Subject: McGuire Nuclear Station
Docket Numbers 50-369 and -370
Catawba Nuclear Station
Docket Numbers 50-413 and -414
Technical Specification Revision to Change Method of
Measuring Reactor Coolant System Flow Rate; Supplemental
Information

REQUEST FOR ADDITIONAL INFORMATION
REACTOR COOLANT SYSTEM (RCS) FLOW MEASUREMENT METHODOLOGY

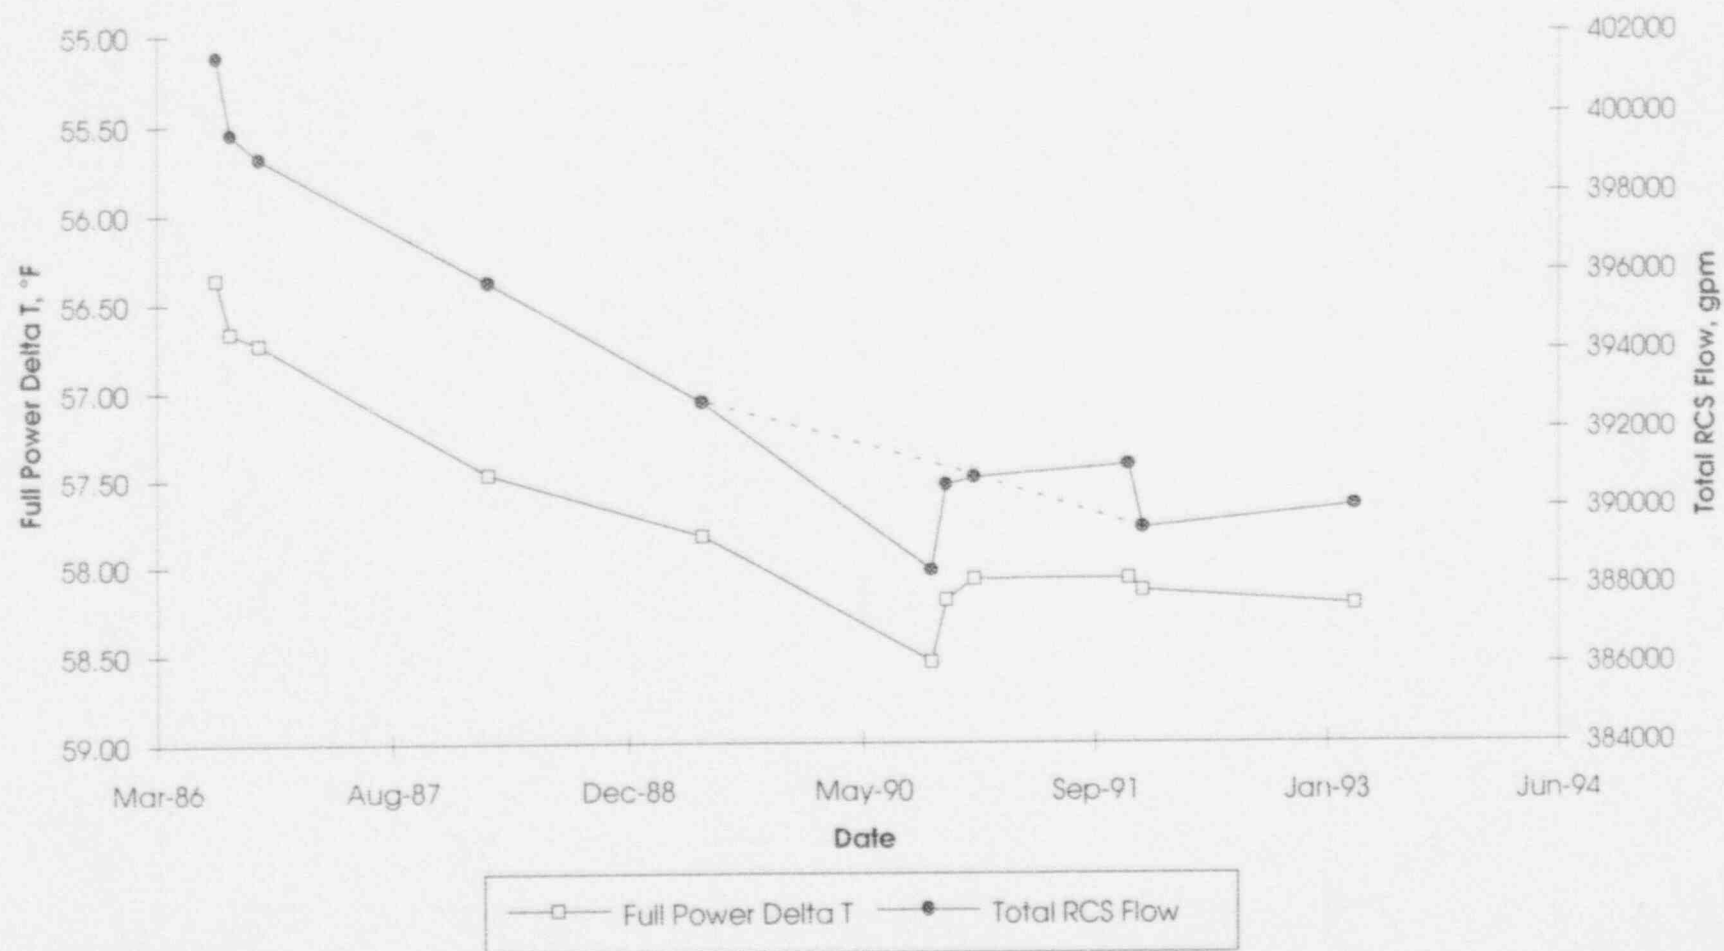
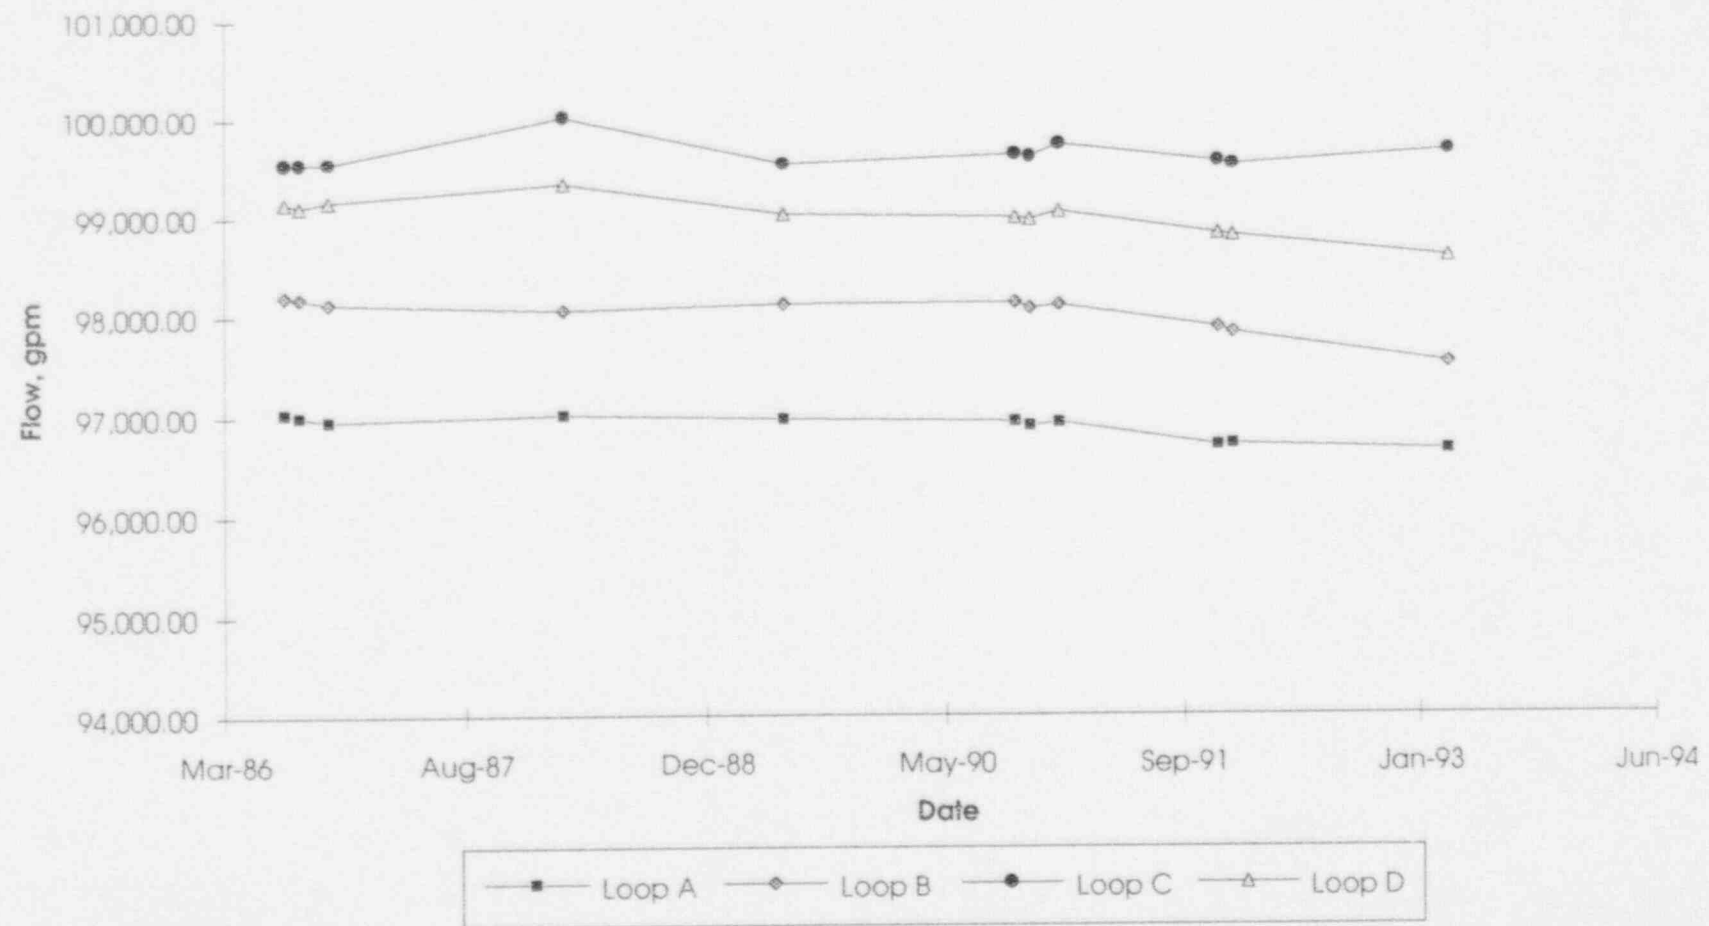
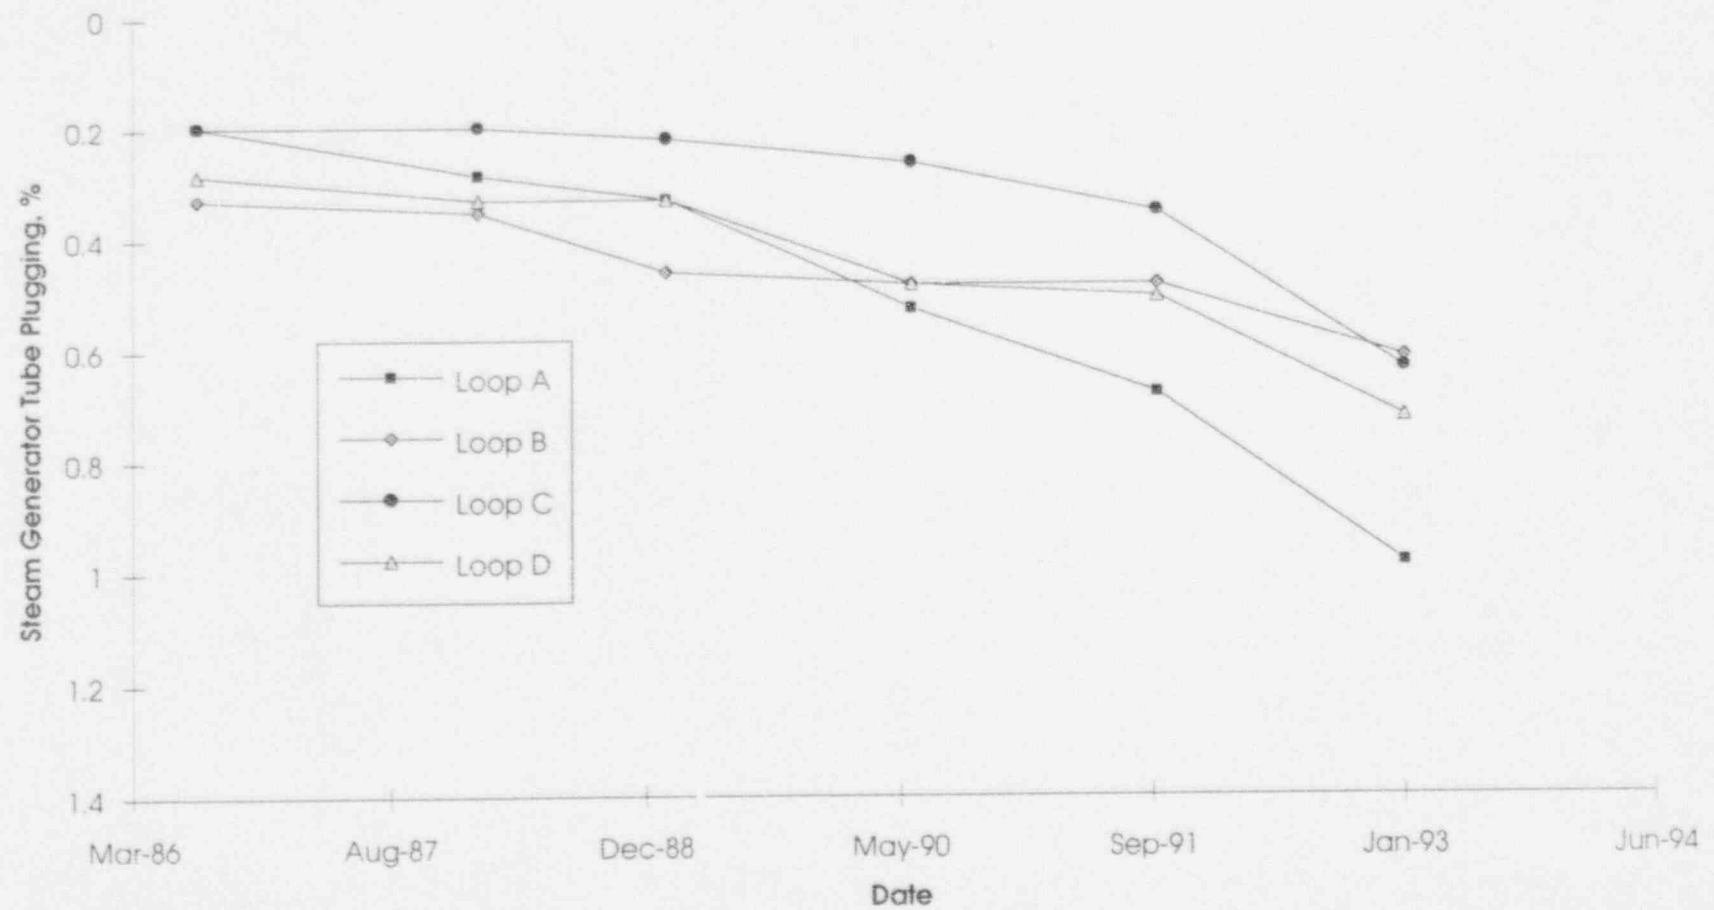
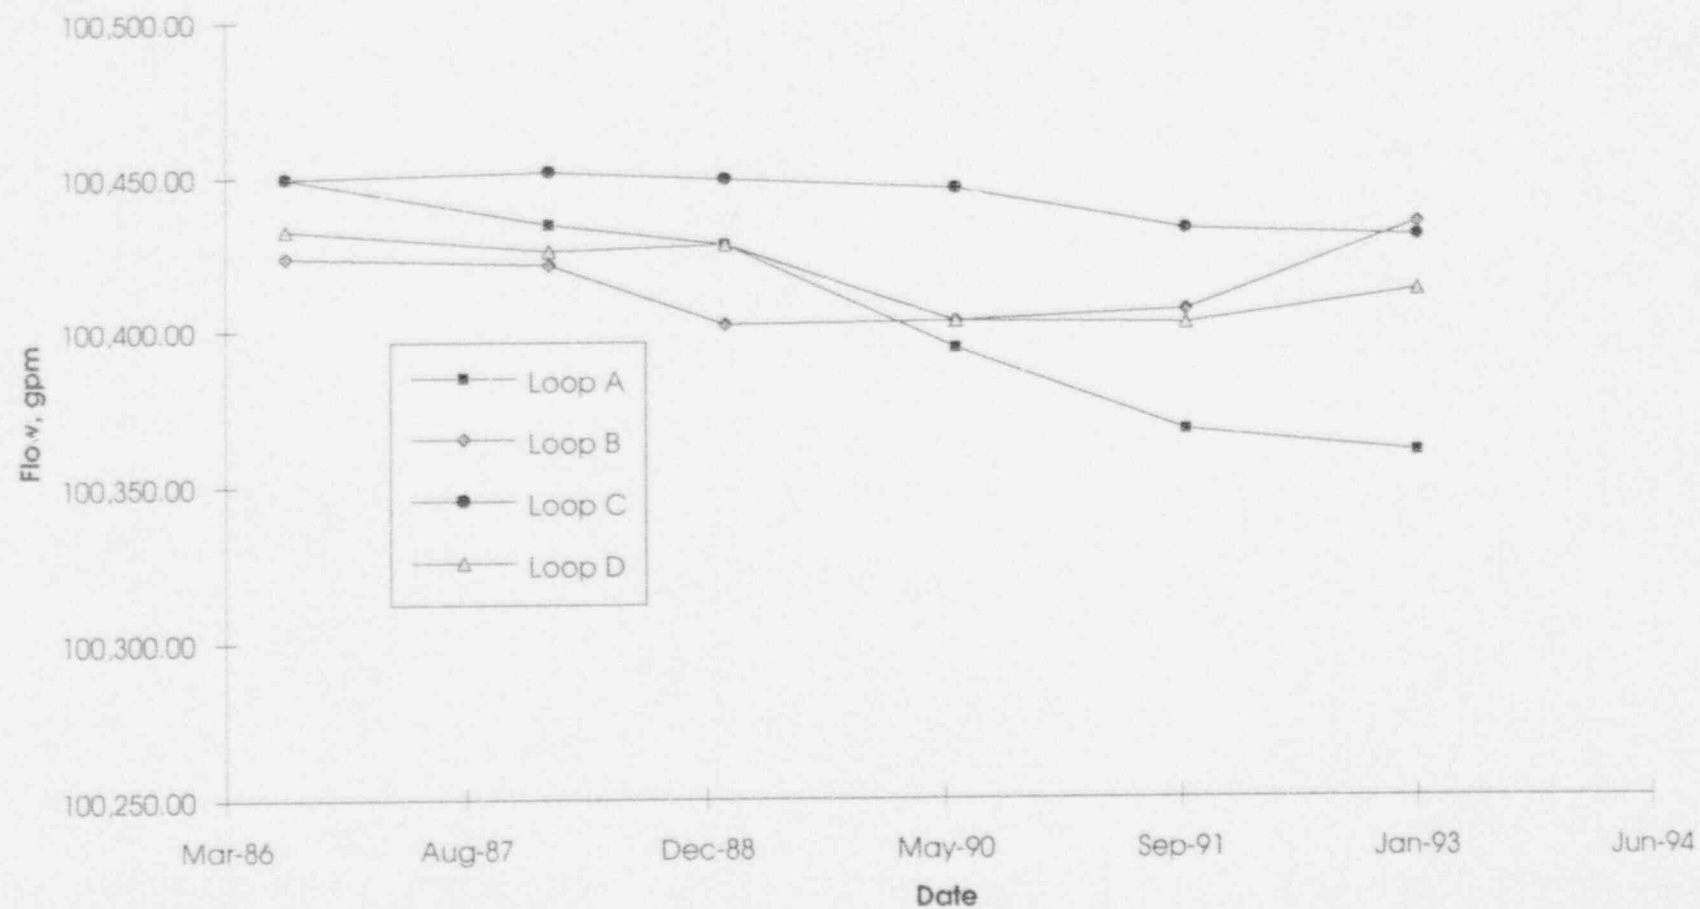
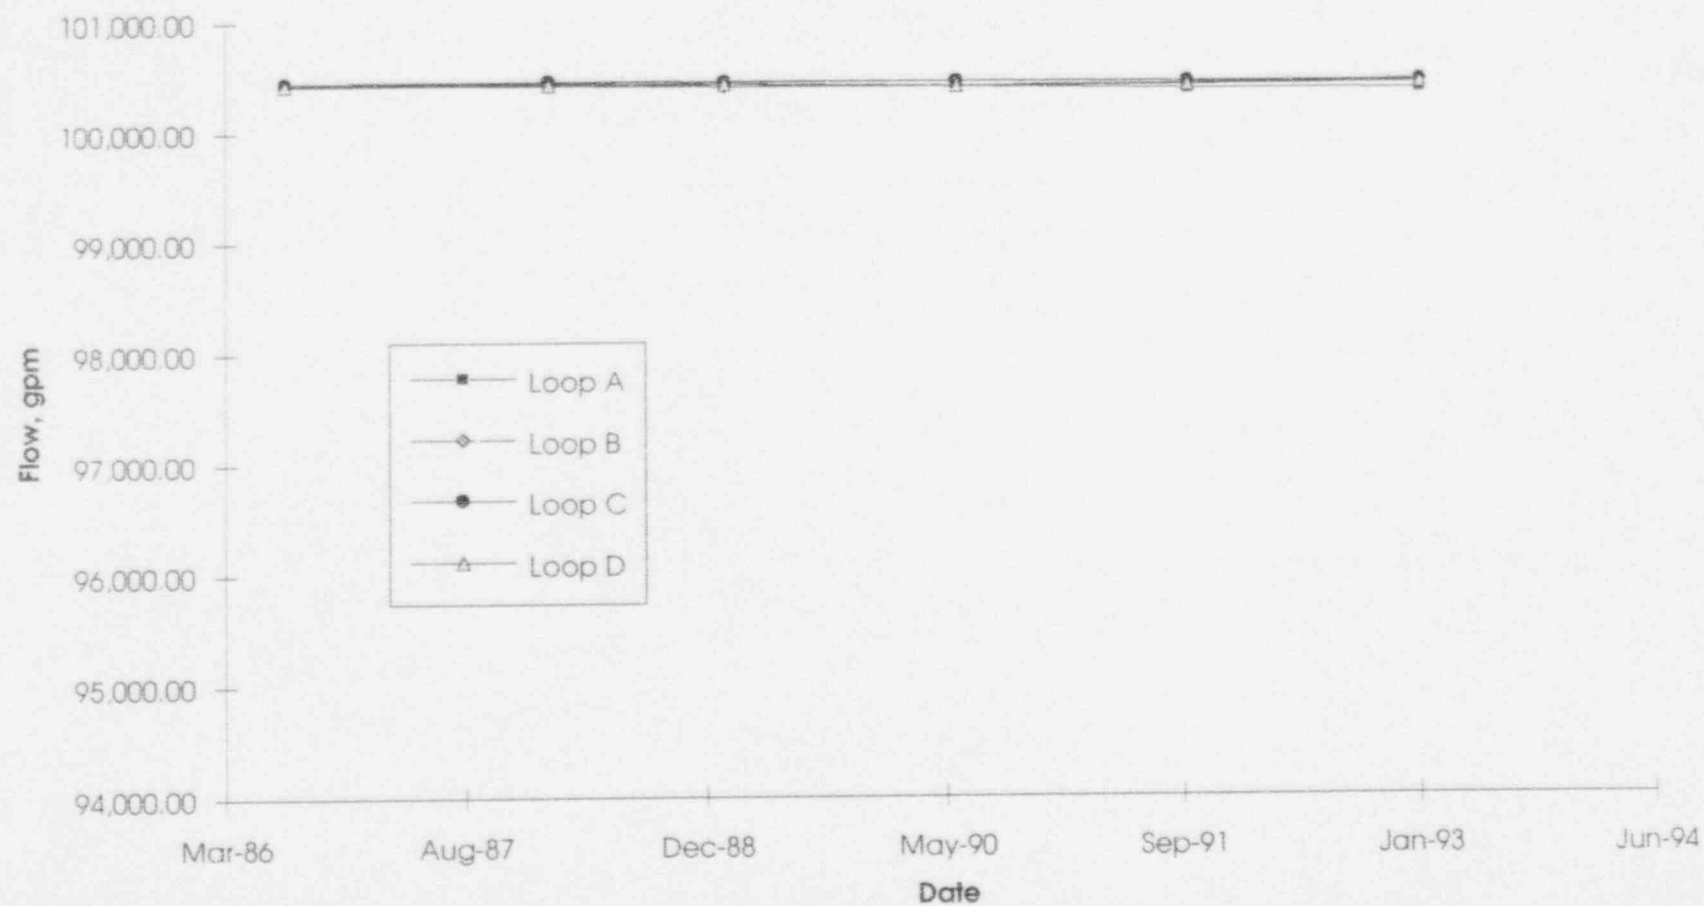
- (13) The data presented on the handouts in the February 10, 1994, meeting shows that the flow rate indicated by the calorimetric heat balance method approximates that indicated by the elbow taps except for the McGuire Unit 2 in 1985, Catawba Unit 2 up until 1990 and Catawba Unit 1 in October 1992 and January 1994. Provide an assessment for each of these divergencies.

Catawba Unit 2 has experienced a substantial flow impact as a result of hot leg streaming in early calorimetrics. The RCS flow as measured by the calorimetric has trended very closely to the changes in full power ΔT as can be seen in Figure 20. The calorimetrics performed between plant startup and the June 1990, EOC 3 refueling outage, indicate unsubstantiated decreases in RCS flow which were not accompanied by significant plant changes. Between October 1990 and January 1992 five calorimetrics were performed. The October 1990 calorimetric was performed with a feedwater pressure transmitter of the wrong range, therefore, the calculated elbow tap coefficients for this calorimetric were not used. Another calorimetric was performed in November 1990, but due to questions concerning the amount of feedwater venturi fouling present, the calculated elbow tap coefficients for this calorimetric were also not used. Following the cleaning of the feedwater venturis the third calorimetric was performed in January 1991. The calculated elbow tap coefficients for this calorimetric were used for the remainder of Cycle 4. The calorimetric performed following the EOC 4 refueling outage in December 1991 was not used to establish the new elbow tap coefficients since it was discovered that a drain valve

on a transmitter installed for the calorimetric was leaking. The calorimetric performed January 1992 was used to calculate the elbow tap coefficients for Cycle 5. When using these two "good" calorimetries (January 1991 and January 1992) the calorimetric flow, as indicated by the dashed line on Figure 20, after the June 1989 calorimetric trend slightly downward consistent with the increasing trend in ΔT , but in excess of that expected by the very small amount of steam generator tube plugging (Figure 22). In the period between plant startup and the October 1990 calorimetric, the calorimetric flows have indicated that the total RCS flow has dropped approximately 13,000 gpm (Figure 20) whereas the elbow tap and analytical model flow have indicated a drop in total flow of approximately 150 gpm (Figures 21, 23 & 24). Note, Figures 23 & 24 differ only in the Y-axis scale with the scale on Figure 24 matching the scale of Figure 21 for easy comparison. This indicates a significant impact from hot leg streaming as it shows that 12,850 gpm of the calorimetric flow decrease in this time frame can be attributed to this phenomenon.

The first batch of B&W fuel was introduced during the February 1993 EOC 5 refueling outage. The B&W fuel was expected to increase flow slightly due the decreased flow resistance in the core. The flow in the plant as indicated by the elbow tap ΔP s and the analytical flow model did not change appreciably, i. e., a very small increase in flow, while the calorimetric flow also showed a slight increase after this outage.

The decreases in RCS flow for Catawba Unit 2 prior to 1990 were the result of increases in indicated ΔT caused by changes in hot leg streaming patterns. The Catawba Unit 2 plot of indicated full power ΔT in Figure 13 shows that the indicated ΔT up to 1990 increased approximately 2 °F. This increase in ΔT represents a decrease in flow of approximately 13,000 gpm while the changes in elbow tap ΔP indicate a flow decrease of approximately 150 gpm. Very little steam generator tube plugging was performed during this time frame as indicated in Figure 15, therefore, very little decrease in the RCS flowrate should have been observed.
